# Recall Campaign

Daimler Trucks  
North America LLC

FL747AB

## Subject: TBB Freedman 3-Point Seat Belt Brackets

**Figure 2: Drilling Location & Bracket Alignment**

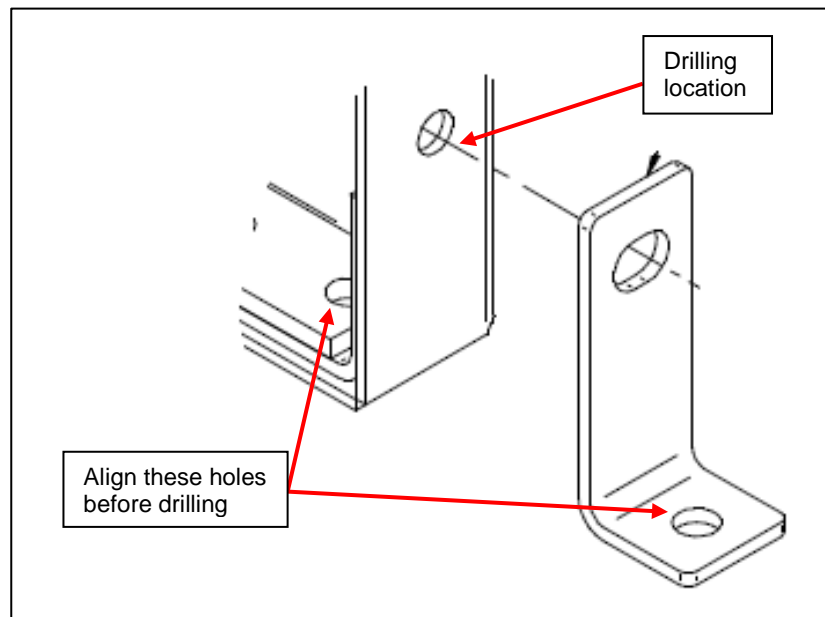
4. Align the new bracket with the back of the seat pedestal as shown in **Figure 2**. The back of the bracket and the seat should be flush, with the bracket centered on the seat at the floor.
5. Mark the drilling location on both the pedestal and the floor.

6. Remove the bracket and drill a 7/32 in. hole in the pedestal (first drilling a pilot hole if needed).
7. Drill a hole completely through the floor with a 25/64 in. bit, taking care not to damage the floor covering.
8. Install the bracket (from Freedman kit 89750) as shown in **Figure 3**.
  - 8.1 Install the bolt (TBB 170728) through the bracket, the hole drilled earlier, and the floor. Add washer (TBB 69004123) and nut (TBB 170735) to the bolt underneath the floor.
  - 8.2 If the bolt falls on a Z-channel, in addition to step 8.1, install a floor channel reinforcement (C2: TBB 1205077 or HDX: TBB 46016639) and use a longer bolt (TBB 170731).
  - 8.3 Tighten to 12-14 lbf-lbs.
  - 8.4 Apply undercoating to the underside of the bus at the bracket holes.
